Rhode Island Airport Corporation Air Quality Monitoring Work Plan

for TF Green Airport, Warwick, RI **April 2015**

Addendum E: Public Comments

Subject: Amendment to Air Quality Monitoring Work Plan Written Comments

Attachment: AQ 2015 Work Plan Drawing .PDF

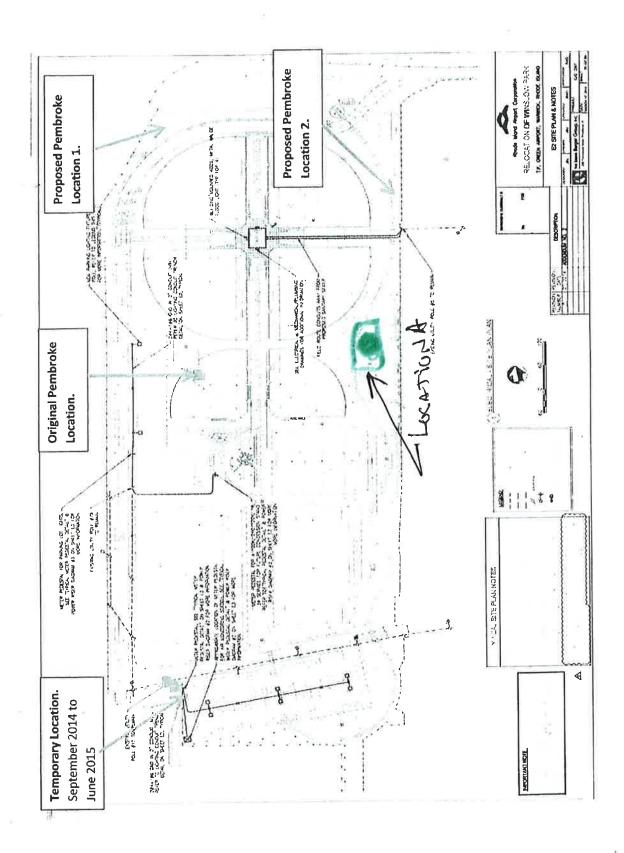
At the hearing, there was mention that RIAC would consider alternate sites in addition to those proposed in the draft work plan. With that, I am submitting and requesting an additional site be added to the Final Work Plan and included for agency review. The additional proposed location is identified as "Site A". I believe Site A is the most appropriate site given the selection criteria and intent of guiding statutory regulations

The location for Site A is identified on a drawing that is attached as *file "AQ 2015 Work Plan Drawing .PDF"*. Within that drawing, Site A is identified as a green colored box, with an identifying arrowhead labeled "Site A". Site A is immediately east of the original Pembroke Site, and adjacent to the walking path on the east side of the playing fields.

Benefits: Site A is closest to the original Pembroke Site, it is immediately cross-ball field of airfield supplied air currents, the tot lot, the playing fields, and closest to the neighborhood. No other proposed site offers these benefits. It is further from the access roadway than the other sites. Site A can be electrified and supplied with a data line. While an access gate for service may be needed, this is minor and opens opportunity to add contiguous room for stockpiling snow during winter months. It would allow resident monitoring of AQ monitoring service vehicles, something I've learned neighbors like to see taking place as it reminds them the AQ program is in effect.

With the above Site A, I am modifying, updating, and amending my public hearing comment preference to a <u>Preference for Site A</u> with a 2nd and lesser preference for Site 2, and a firm Objection to Site 1.

Site 1 (Opposed)

Disagree with RIAC's comment that this site best addressed concerns
 Site A best addresses concerns and Site 2 addresses concerns more completely than Site 1.

Site 1 is not the best sited and does not address several concerns. The intent for the program is to study impact on public health and with that there has been a longstanding goal to locate the monitoring sites as close to people, the public, and residential properties as possible. Site 1 does not meet this criteria or these needs.

- Site 1 being closer to runway end. Being close to the runway end is not a goal. The Goal is to place the monitoring site closest to the public and residences. Site A and alternately Site 2 better meet this key criteria.

- Site 1 has the disadvantage of not being closest to people, and closest to people is where the air should be sampled. Therefore Site 1 should be rejected.

- I agree Site 2 is a viable site Site 2 is closer to residences than Site 1 and therefore better meets the goals of the study and is more consistent with the intent of GL 1-7
- Vehicular Traffic: Site 2 may include impact of vehicular traffic, however post sampling analytics are able to distinguish and sort this out. Inclusion of all HAPS sources is a goal of both the FEIS/ROD and GL 1-7 and is beneficial to the ongoing study.
- Aesthetic acceptability is not a major factor and is a lower priority than selecting the best site for sampling air that has passed over the fields and is closest to the public
- Site 2 is my 2nd preferred alternative site.

Site A - 1st Choice Preferred Alternative

- Site A is downwind of the athletic facility and airfield source directional air currents and is most appropriate as the air sampled would be most representative of air passing over the tot lot, ball fields, sports complex, in-line with the airfield main runway, and closer to residences.

- Site A is closest to the original Pembroke Site, it is immediately cross-field of air-side origin air currents, the tot lot, the playing fields, and closest to the neighborhood. It is further from the access roadways than Sites 1 and 2. It can be electrified and supplied with a data line. While an access gate for service may be needed, this is minor and opens opportunity to add contiguous room for stockpiling snow during winter months. It would allow resident monitoring of attending service vehicles, something I've learned neighbors like to see taking place as it reminds them the AQ program is in effect. Site A is my 1st Preferred Site
